LIGO- T1400652-v1

Technical Proposal to the Vacuum Review Board (VRB)
for
Decommissioning the LHO Mid-Station Cryopumps

Dennis Coyne

Figure 5: Bi-Braze Joints (5 bi-braze joints indicated by red ellipses)

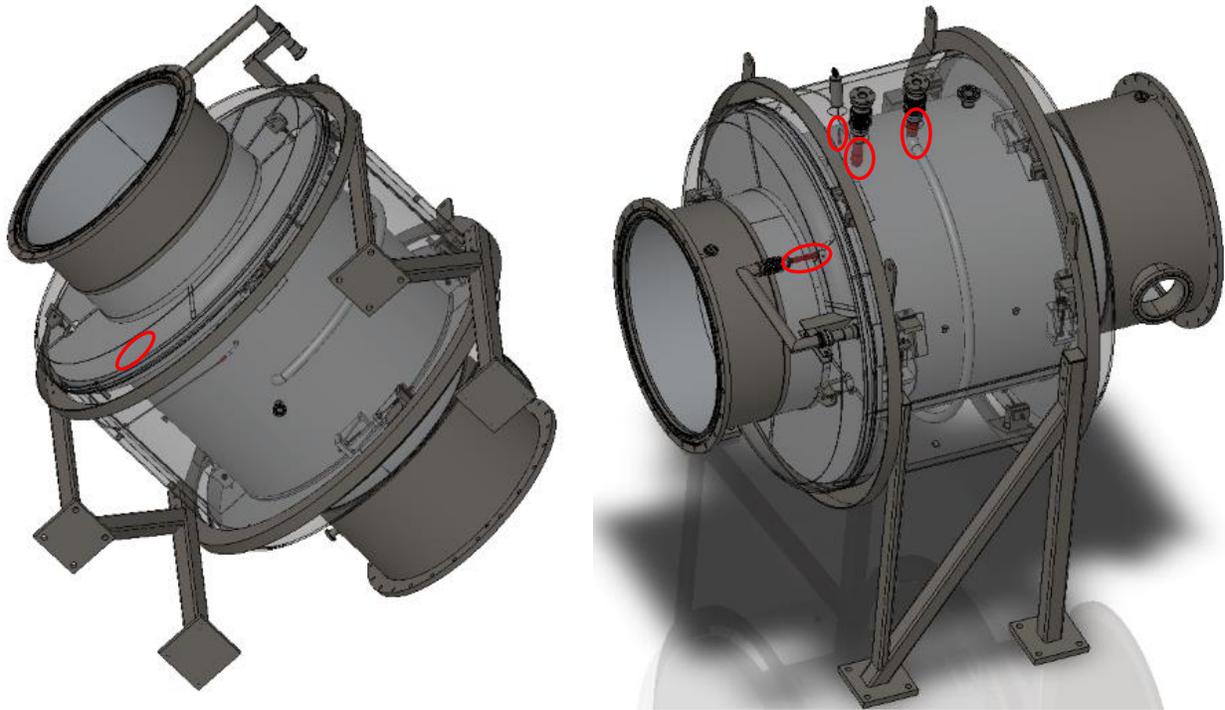
PSI had some difficulty with the bi-braze joints and elected to proof test (cryo cycle) all units before accepting and welding them into our 80k pumps. Many of the units failed this cryo cycle testing. We do not know if PSI used units that survived the cycle testing but were built with the same design & manufacturing process, or if they switched to another design/process in which all units survived the cryo cycle testing; **speack with Rich Bagley.**) The attached drawing shows how they are configured inside the pump.

We have regenerated the LLO cryopumps without incident ca. 2003 or 2004 (maybe). LN2 consumption declined measurably afterward, presumably because the low emissivity of the cold surface was restored. Although initial testing can exhibit good tensile strength results, in service the CTE stresses between the two dissimilar materials can cause braze failure (often due to brittle intermetallic compounds)^{1,2}.

Although LLO has successfully cycled/regenerated their cryopump a couple (few?) times, this is not sufficient testing to insure that future failures will not occur. Given the significant downtime that this risk entails it is the VRB's strong recommendation that measures be taken to accommodate a failure of the b-brazed joint in case it should occur.

The bi-braze joints are shown in [D970362](#)-x0, sheet 2 (PSI drawing V049-4-090, Rev. 2, sheet 2, "80K Pump Reservoir – short-right"). This reservoir is a subassembly of the overall 80K Cryopump ([D961096](#)-x0, PSI drawing V049-4-005, "80K Pump General Arrangement – short-right").

The bi-braze specification is PSI document WI-015-004, called out in the drawing (but we don't have a copy?). Neither the PSI plan for the 80K Cryopump Fabrication (V049-2-082, Rev. 0) nor the PSI specification for the 80K Cryopump Fabrication (V049-2-096, Rev. 1), nor the PSI Welding Specification (??) mention the bi-braze.

The VRB recommends that a means of isolating the vacuum containment (envelope) in the event that a bi-braze joint fails (leaks). While it is not possible to prevent communication from the cryo reservoir to the vacuum, it should be possible to seal the LN2 inlet, LN2 level control port, the regen GN2 port, and the GN2 vent port, and pull a vacuum on the interior of the reservoir. **<conceptually how can this be accomplished?>**

The VRB recommends that a design to accomplish the isolation be pursued and implemented prior to warming up the LHO mid-station cryopumps.

We assume that one (or more) of the bi-braze joints will fail, and prepare for this eventuality by connecting evacuating the LN2 reservoir volume. Two approaches could be employed:

For either approach the five ports into the LN2 reservoir must be sealed (by plugging or connecting to each other and/or a vacuum source). Two of the LN2 reservoir ports are FPT (female pipe thread) fittings. Pipe thread joints are not appropriate for ultra-high vacuum systems and their use should be avoided in high-vacuum systems^{3,4}. A potential solution to the leak reliability of the NPT fitting is to silver solder the threaded joint (using capillary action to draw the solder into the threaded interface). However this approach will not reduce the potentially significant volume of trapped gas volume in the threads. A better approach is to silver solder a plug to the face of the FPT fitting without resorting to a mating thread fit. A soldered joint is preferred over a weld or braze because less heat input is required. As a consequence there is less risk of damage to the threaded joint, or the nearby bi-braze joint.

The three other ports into the LN2 reservoir (LN2 Inlet, GN2 Vent and Regen GN2) are ASA-5-200N type fittings. The ASA flange is an ANSI flange standard with an elastomeric o-ring seal and can be used for vacuum applications⁵. The LN2 Inlet and Regen GN2 ports can be capped with an ASA blankoffs. Without the LN2 there is no longer a need for the Rupture Disk (4.5" OD CF), so this can be removed and the port connected with a UHV flexible hose to the GN2 Vent port (which has the least resistance into the reservoir). In order to accomplish this connection the following parts are needed:
